RESPONSE TO COUNCIL'S CONTENTIONS

22-24 Park Road in Auburn

A14138916N (Version 1b)

July 2021

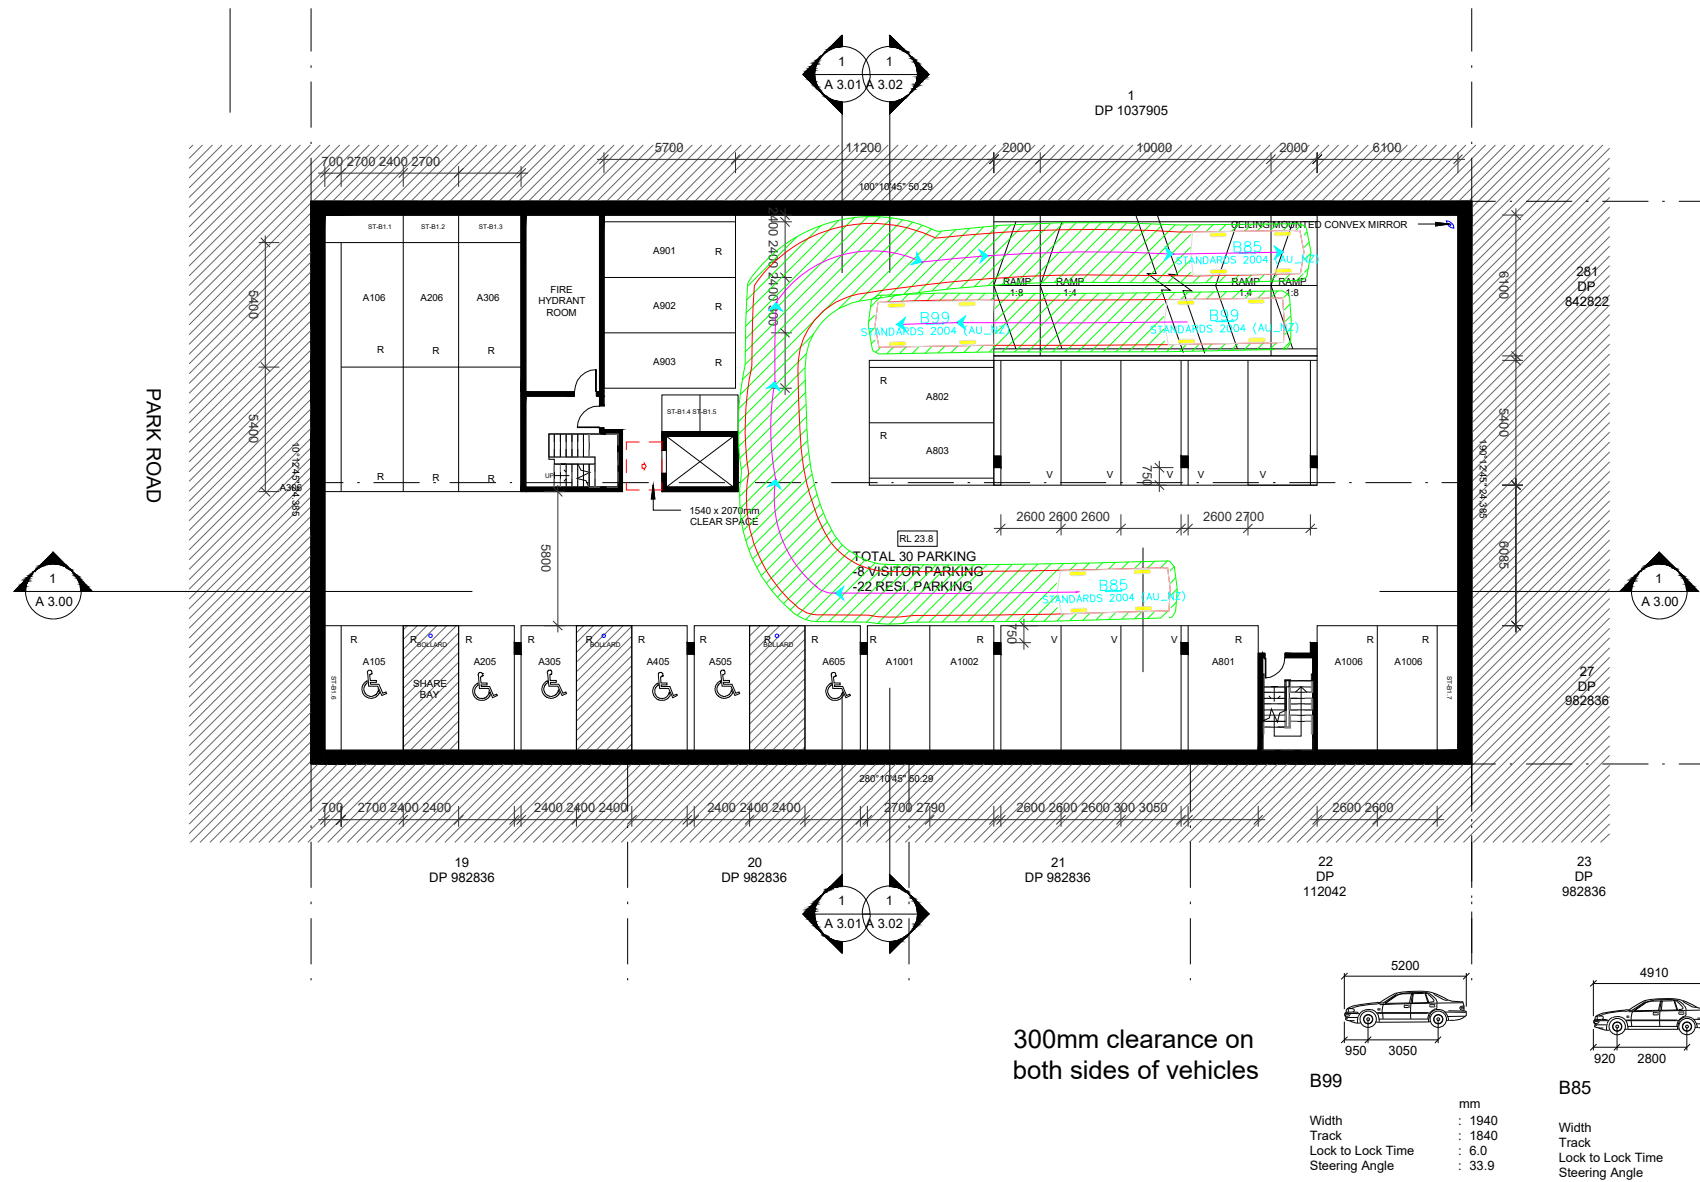
Contention 10

The width of the southern and western most circulation aisles at basement levels 1, 2, and 3 fail to comply with the 6.1m minimum width requirements of AS2890 and in doing so, fail to provide for adequate circulation.

As required in AS2890.1, for circulation roadways, a minimum width of $5.5\text{m} + 0.3 \times 2 = 6.1\text{ m}$ must be provided. This width is provided in the current design, see the figure below:

As discussed previously, the implementation of traffic light system with waiting bays will address Council's contentions in full.

APPENDIX A – SWEPT PATHS

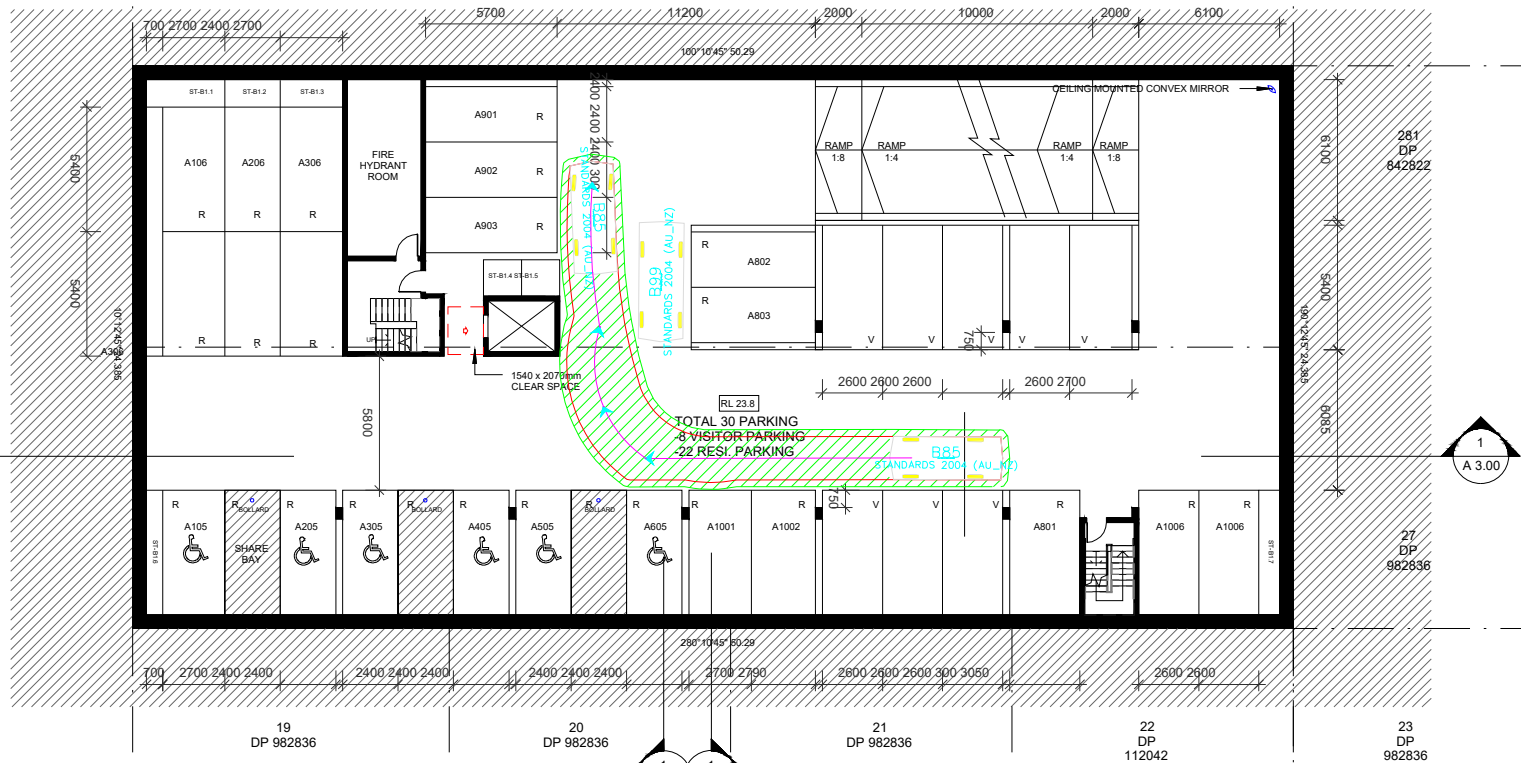
Contention 9

Insufficient manoeuvring area has been provided west of parking spaces A301, A302, A802 and A803 to enable cars travelling in opposite directions to pass each other. A swept path analysis is required to demonstrate sufficient manoeuvring area.

The above car spaces are located on Basement 1.

The swept paths do not show simultaneous two way movements.

A traffic light system with waiting bays are recommended.
